Rezoning Transportation Analysis

Petition Number: 2017-203

General Location Identifier: 11907623, 11907624, 11907622

| Date | Description |
|------------|--------------|
| 01-12-2018 | First Review |

Figure 7: South Tryon Segment 1 Proposed Section (Near term)

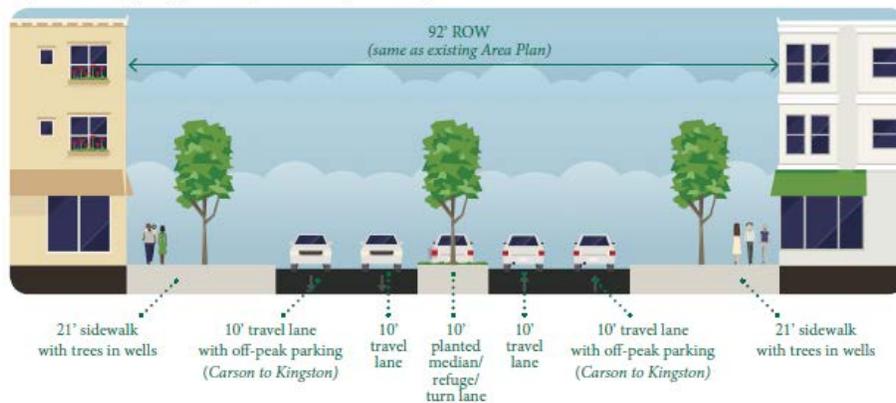
- The recent South Tryon Corridor Study proposed a future cross-section that includes 7 foot raised bike lane. The petitioner should revise the site plan to show the future curbline as noted in Comment 1a for zoning purposes but construct the interim curbline at 27.5' from centerline and remove the future recessed parking on South Tryon St. Below are the future cross-sections of South Tryon St:
